DEVELOPMENT REVIEW BOARD

REGULAR MEETING MEMORANDUM

Item No. 4
Meeting Date: 7/16/2020
Topic: Updates to Material Board and Elevations
Request: Approve revised stipulations
From: Jeff Barnes, Senior Planner **JB**
Through: Brad Carr, AICP, LEED-AP, Development Review Board Coordinator **B**

Silver King Office & Car Storage 55-DR-2019

55-DR-2019
7/8/2020
A202
EXTERIOR ELEVATIONS
COLOR ALT

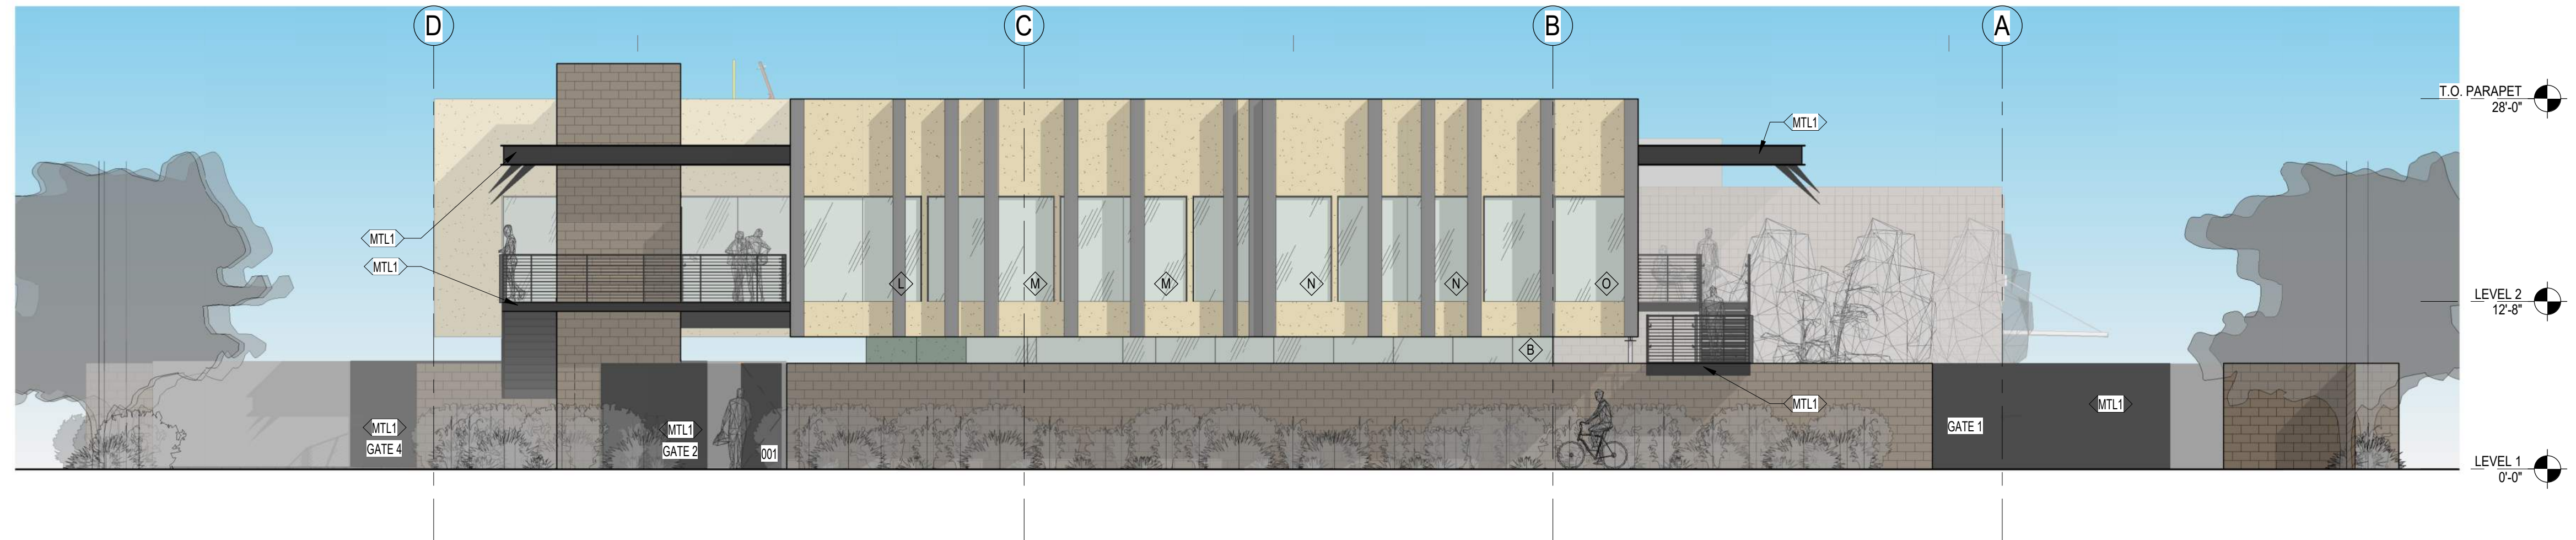
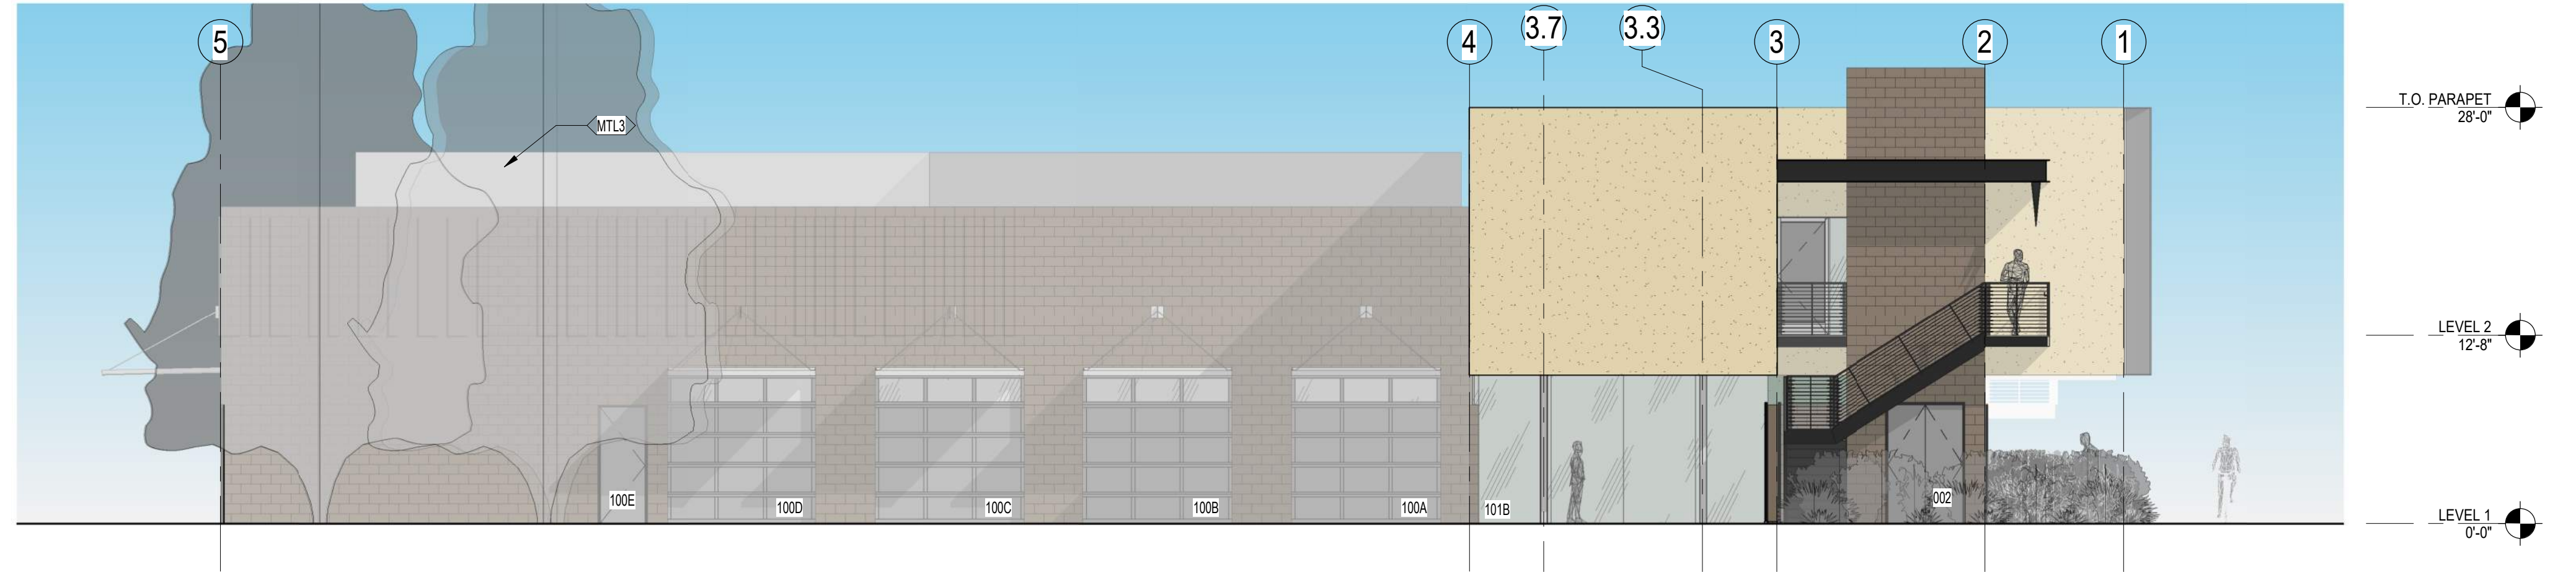
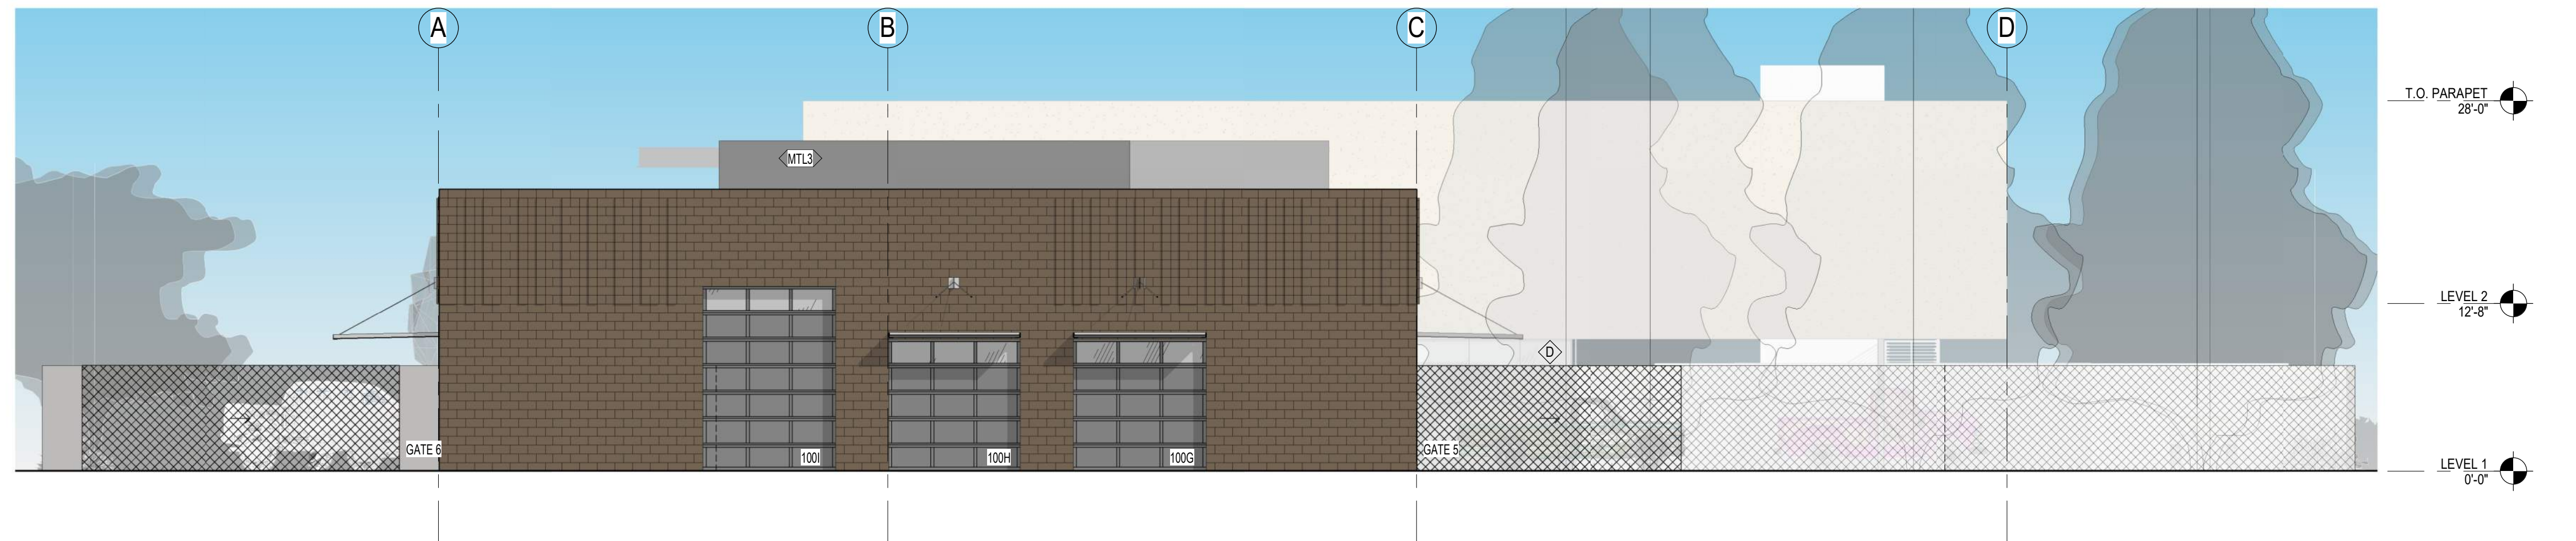
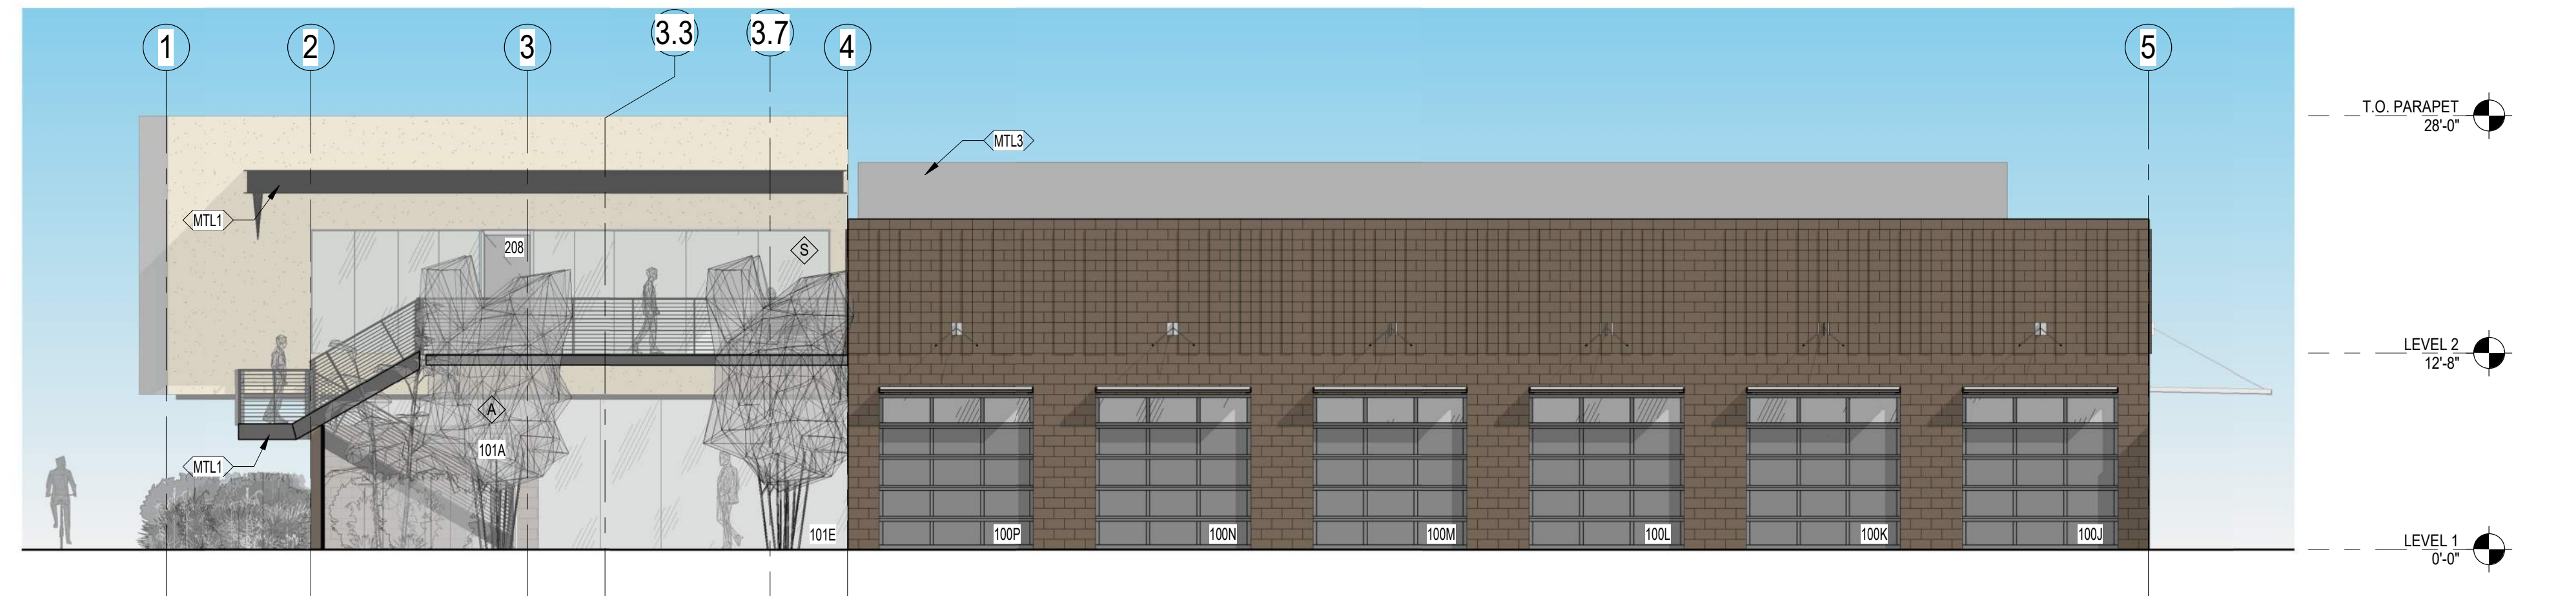
The applicant made adjustments to the proposed site plan and elevations to address expressed visual massing and site configuration concerns but did not change the proposed color palette / material board at that time. On 7/8/2020 the applicant provided an update to the proposed colors and materials to address the staff recommended Stipulation #4 which identified that the color and material choices shall be revised to emphasize muted earth tones and address the Sonoran Desert environment. Unfortunately, these modifications came too late to be addressed in the staff report before it was published.

Please consider in your action using the updated document date of 7/8/2020 for Stipulation #1 and striking the current language in Stipulation #4:

- a. Architectural elements, including dimensions, materials, form, color, and texture shall be constructed to be consistent with the building elevations submitted by Architekton, with a city staff date of ~~6/4/2020~~ **7/8/2020**.

- ~~4. In accordance with the City of Scottsdale Commercial Design Guidelines, the color and material choices shall be revised to emphasize muted earth tones and address the Sonoran Desert environment. Including but not limited to the following:~~

- ~~a. A change in hue of the color palette from the currently proposed cool neutral tones to a selection of warm neutral tones.~~
 - ~~b. A reduction in the LRV of the currently proposed "Frostbite" (DE6274) [LRV 77] to a paint color with a maximum LRV of 70%.~~

- ~~c. A selection of block (or stone) that contains/conveys more earth tones than the "Standard Grey" CMU currently proposed.~~
